# Attachment C

## Snowy 2.0 cost is considerably more than \$5B

**Ever-increasing Capital Cost Estimate**

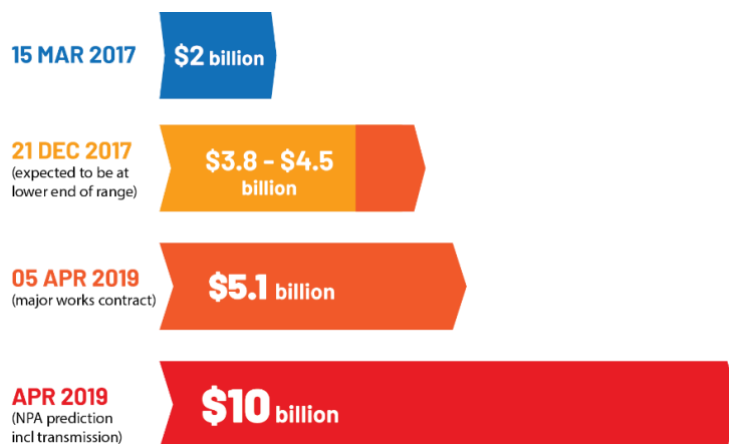
It is patently clear that the cost of Snowy 2.0 will be considerably more than \$5 billion, even using Snowy Hydro’s various estimates:

- The Feasibility Study estimate of \$3.8 - \$4.5 billion excluded certain costs
- A single contract was awarded for \$5.1 billion
- The EIS estimate of \$4.6 billion again excluded certain costs

Snowy Hydro have not provided any information on the excluded costs, but they will be substantial.
